MIRAVAL
SPECIFIC PLAN
CO23-96-1

Adopted by Ordinance #1998-41 June 16, 1998
Amendment Resolution 2006-332 Approved 12/12/06
Original document revised 12/06

RESOLUTION NO. 2006- 332

A RESOLUTION OF THE BOARD OF SUPERVISORS OF PIMA COUNTY;
RELATING TO ZONING IN CASE **CO23-96-01 MIRAVAL SPECIFIC PLAN**
LOCATED ON THE EAST AND WEST SIDES OF LAGO DEL ORO PARKWAY
SOUTH OF PINAL/PIMA COUNTY BOUNDARY; AMENDING THE SPECIFIC
PLAN SET FORTH IN ORDINANCE NO. **1998-41**.

AMENDMENT NO. 21 BY ORDINANCE NO. 1998-41
TO PIMA COUNTY ZONING MAP NO. 520 TUCSON, AZ.
PORTION OF SECTIONS 1 AND 2 OF T11S R14E.

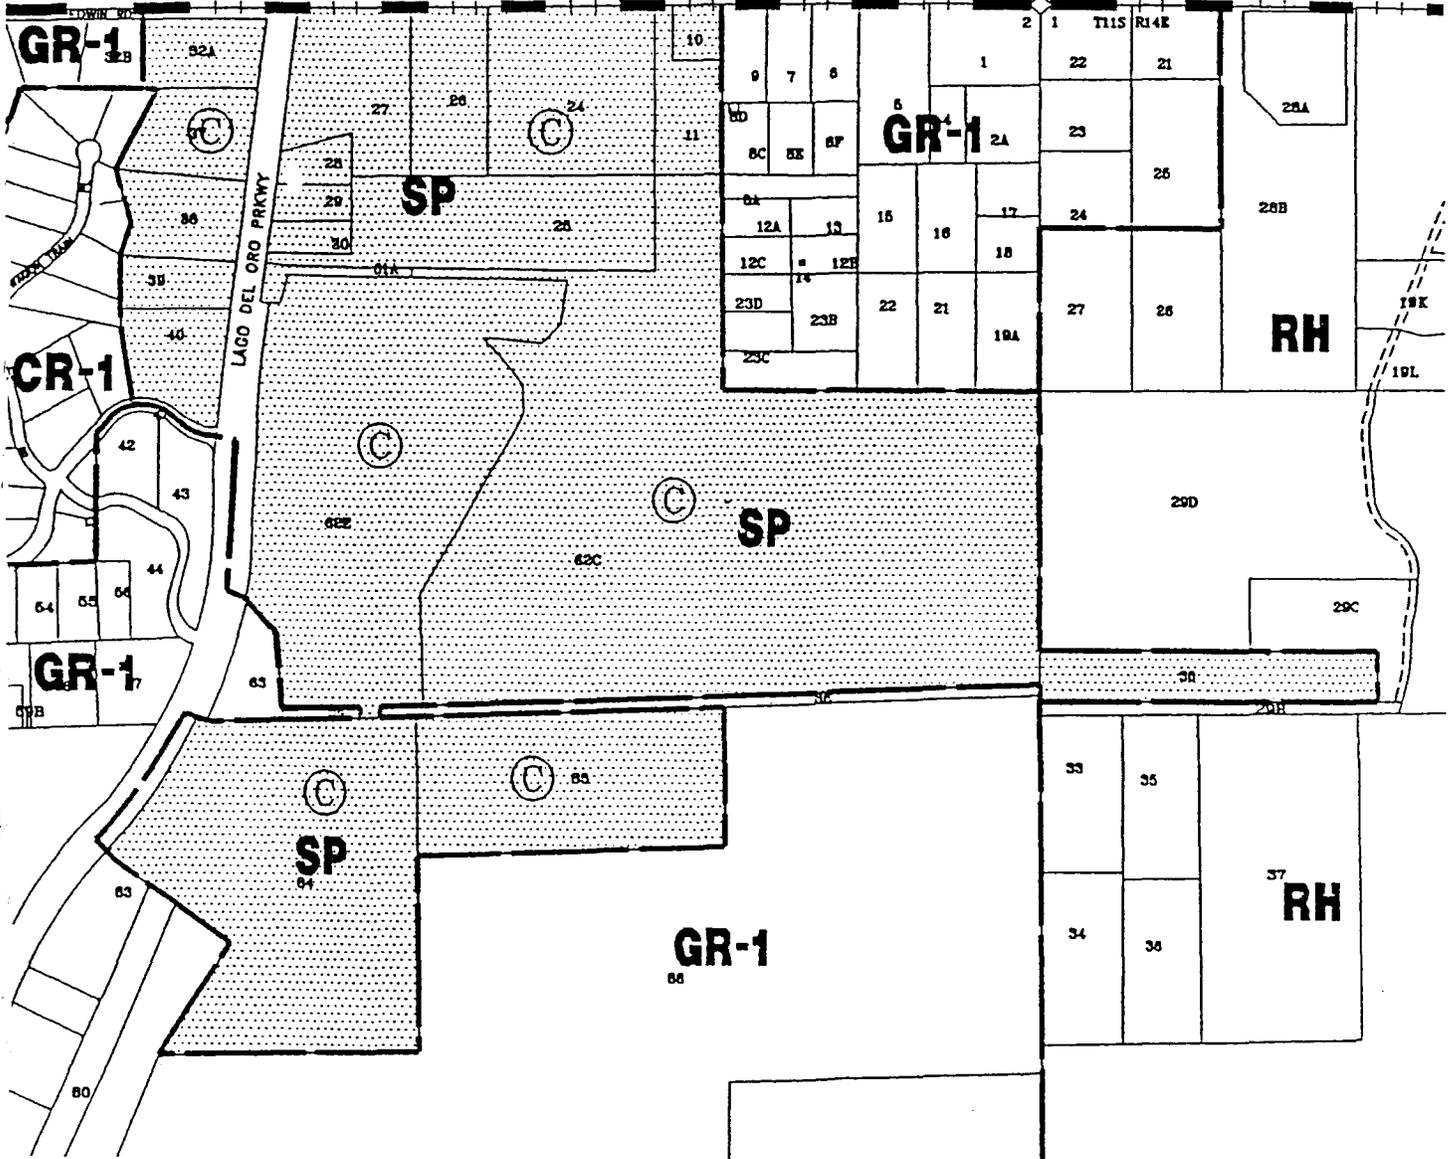
4. On June 10, 2006, the owner(s) of 66.5 acres, which are Development Areas A, E, and G of the specific plan site as shown on Exhibit B (portions of tax parcels 222-02-0250, 222-02-062C, 222-02-062E, 222-02-0840), applied for a modification (non-substantial change) of the specific plan;

5. On August 1, 2006, the Board of Supervisors approved a modification (non-substantial change) of the specific plan for Development Areas A, E, and G as shown on the attached Exhibit B map subject to conditions; the amended conditions are applicable to the area shown on Exhibit B; and
